RE: Installation Restoration Remedial Investigation/Feesibility Study (RI/FS)
Draft Work Plans

ATTACHMENT A NO FURTHER ACTION SITES at Jacksonville NAS

Allaument o Additional Borings for sites 26 and 27 RE WRD letter to TRC deted January, 4, 1991

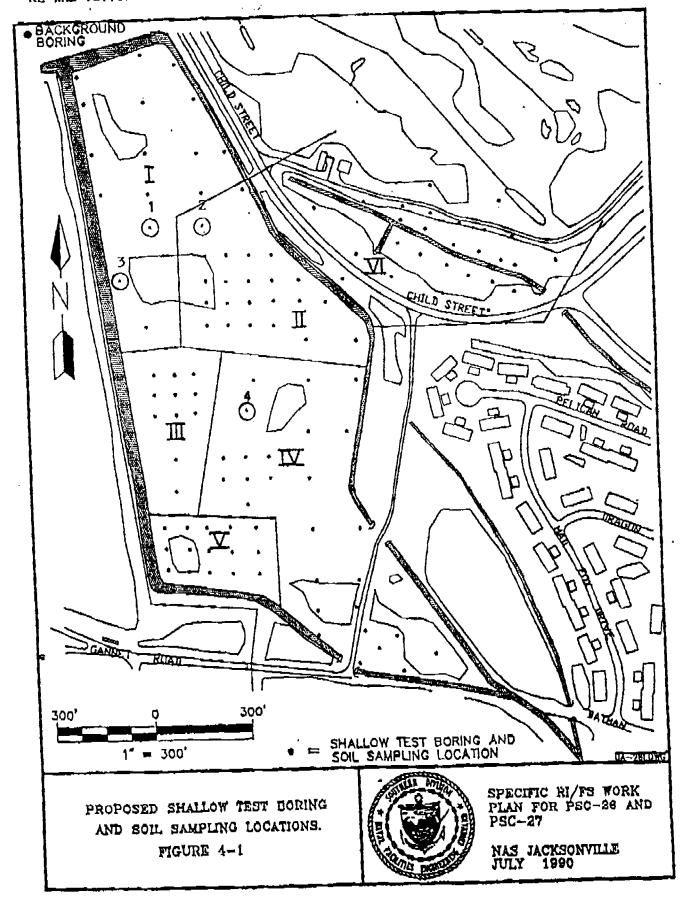
The fourteen (14) sites included in this group are appropriately selected. The WRD agrees that sites 26 and 27 should have the highest cleanup priority and work on these sites should proceed without delay. The WRD proposes the addition of four (4) test boring-soil sampling locations as shown on Attachment B entitled "Additional Boring for Sites 26 and 27".
